Outer Dowsing Offshore Wind

Noise Bund Hydraulic Modelling Report

Document Reference: 15.7

Noise Bund Hydraulic Modelling Report

Figure 2: 2D Model parameters

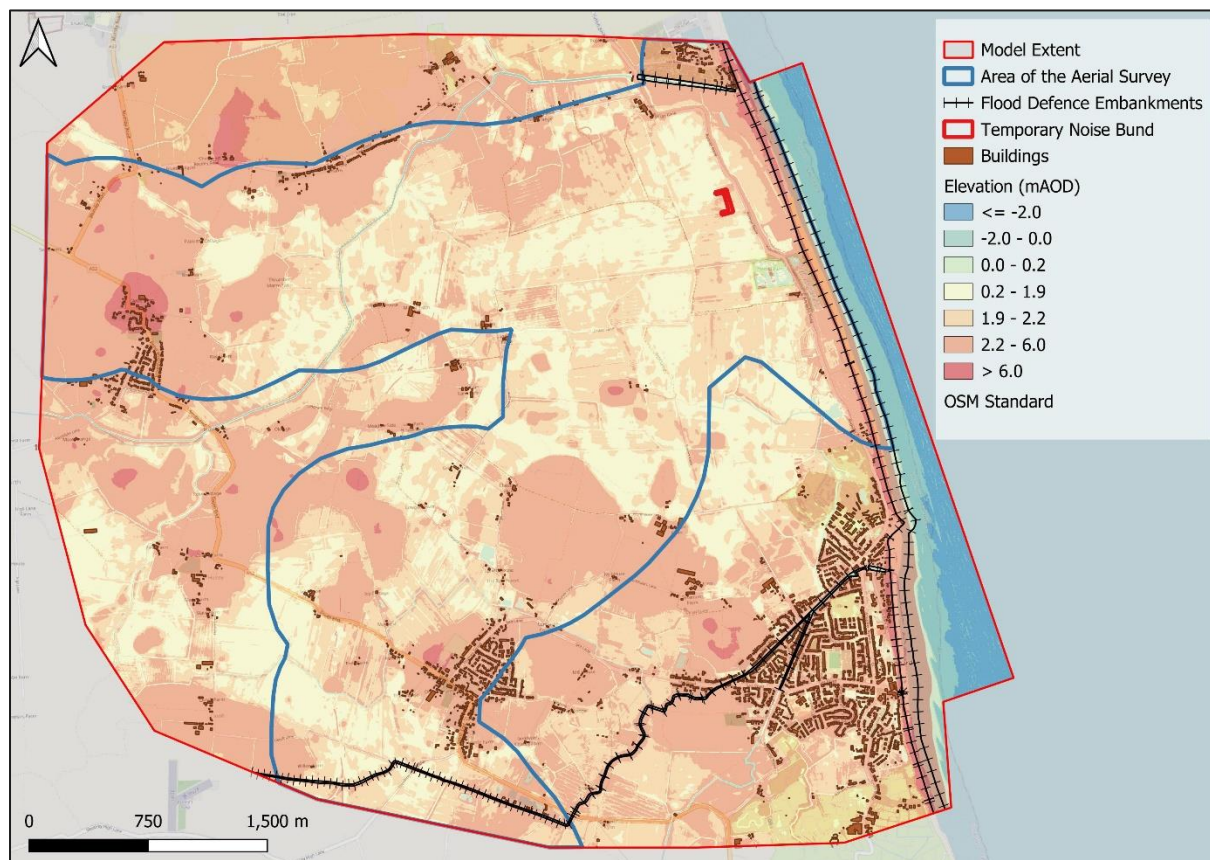
EA Comment	Response
<p>elevations? If so, it is recommended that survey is incorporated.</p>	
<p>The figures do not show the proposed 2D domain extent, although the Methodology states 'The model will extend significantly far inland from the site, so the key flooding mechanisms are not affected by any model boundary conditions. The 2D domain should be sufficiently large to prevent glass walling and allow flood propagation.</p>	<p>This has been amended accordingly.</p>
<p>The methodology shows that the peak tidal curves occur at the start of the simulation with subsequent tidal peaks subsiding. Normal practice is to apply the highest peak in the middle of the simulation.</p>	<p>The tidal curve has been updated with the highest peak in the middle of the simulation.</p>
<p>Defence crests will be represented using Z lines with crests informed from the 'EA Spatial Flood Defences Including Standardised Attributes' layer and cross referenced against LiDAR. This is considered an appropriate methodology. Z Line node locations should be of sufficient frequency in order to represent variations in crest height along its length.</p>	<p>This has been amended accordingly.</p>

8. The hydraulic model domain extends along the beach from Anderby Creek to Chapel St. Leonards. The A52 High Road borders the model on the south and west sides, while the minor road, Sea Road, delineates the northern boundary. To avoid glass walling due to the flat terrain, the model extent has been extended inland. The model extent is illustrated in Figure 2.

Figure 2: LiDAR Elevation (m AOD)

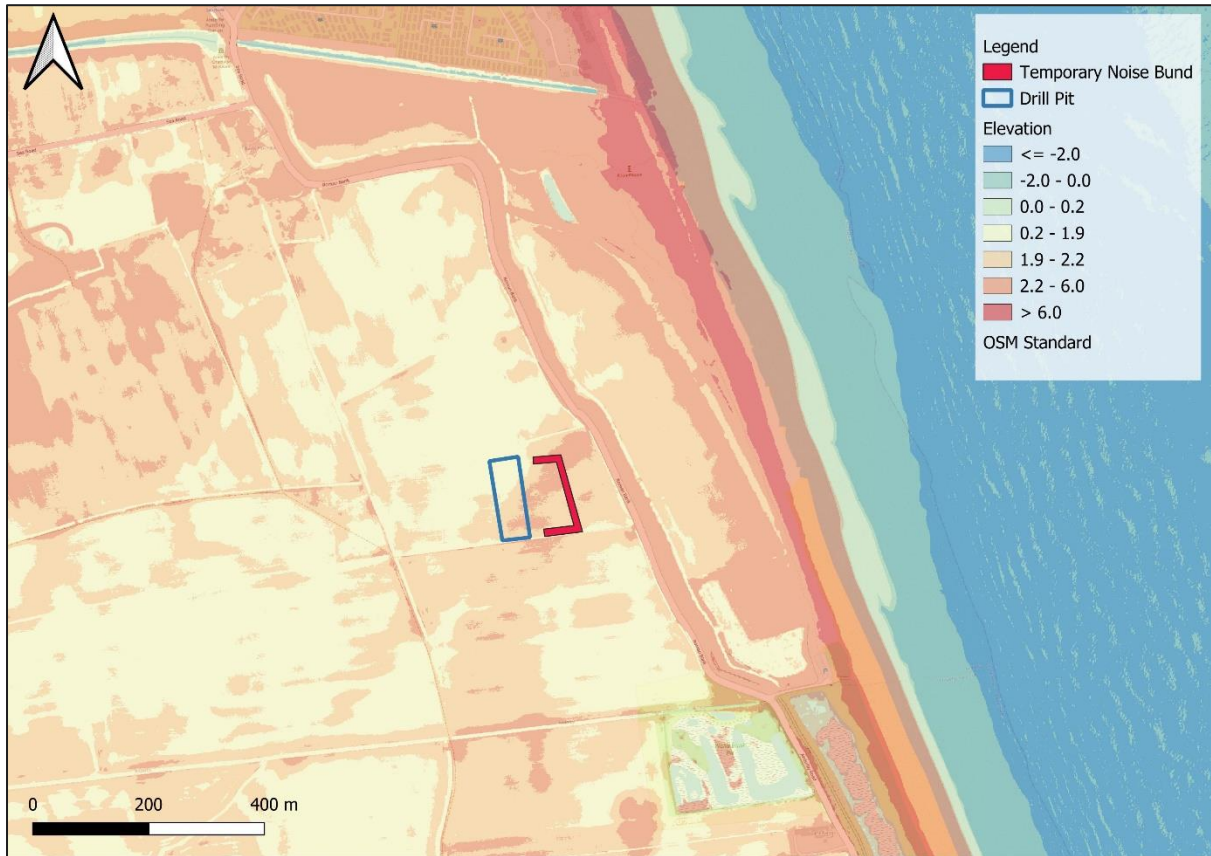
- Figure 2 shows the topography of the area. The sand dune flood defence assets are at a higher elevation than the extreme tidal level of 6m with over 1.6m freeboard, so the site will only be at risk in the event of a breach of the defences.

- The figures do not show the proposed 2D domain extent, although the Methodology states 'The model will extend significantly far inland from the site so the key flooding mechanisms are not affected by any model boundary conditions'. The 2D domain should be sufficiently large to prevent glass walling and allow flood propagation.
